AP1000 Design Certification Review
Draft Safety Evaluation Report Open Item Non-Proprietary Responses

AP1000 DESIGN CERTIFICATION REVIEW

DSER Open Item Number: 21.5-2 Item 19 (Response Revision 5)

DSER Open Item Number: 21.5-2NP Item 29 Revision 2

Figure F-12 ADS-4 Liquid Discharge Comparison

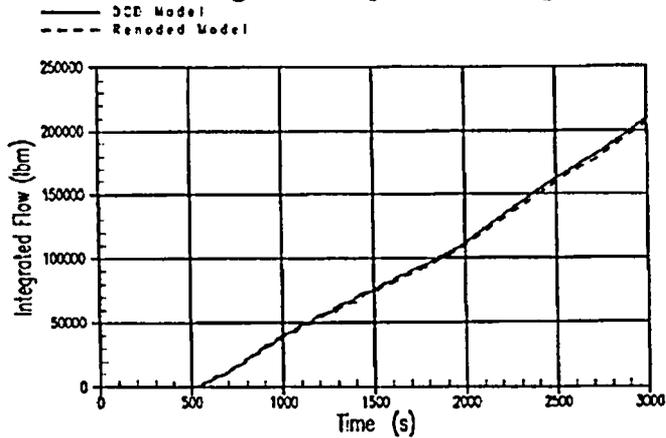
Correct Figure F-12 (i.e., Figure 21.5-1.12) for ADS-4 Liquid Discharge Comparison.

WCAP-15644 Revision 1 will be revised as shown below and issued as WCAP-15644 Revision-2.

Figure F-12 and Figure F-13 present the ADS-4 Integrated liquid and vapor discharges for the two cases respectively. Again, the differences between these two cases are considered to be negligible.

Figure F-14 Downcomer Pressure Comparison

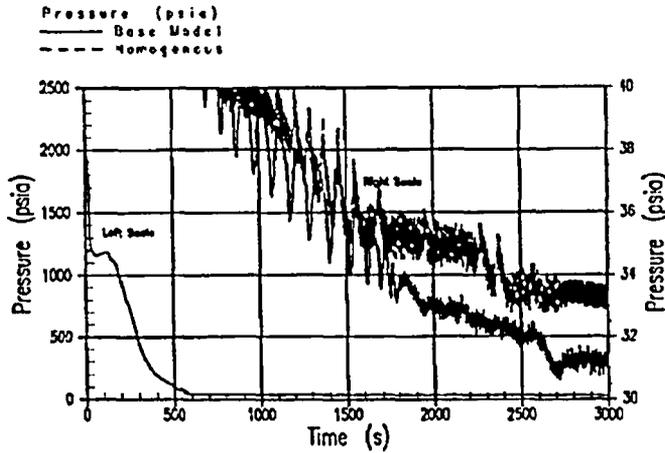
Correct text and Figure F-14 (i.e., Figure 21.5-1.14) to show Downcomer Pressure Comparison.

Figure F-14 presents a comparison of the upper downcomer pressure between the base and sensitivity cases. As can be seen, the sensitivity case results in higher upper downcomer pressure and subsequently results in delayed IRWST injection (Figure F-15). This can also be observed in the intact DVI line flow, which comprises all intact injection flow components (i.e. Accumulator, CMT and IRWST) per Figure F-16. As expected, the initial ADS-4 liquid discharge is much higher (Figure F-17) until the inventory which resided in the upper plenum and hot leg regions was depleted (Figure F-18). The net effect is a decrease in the ADS-4 vapor discharge rate (Figure F-19) and subsequently higher RCS pressures.
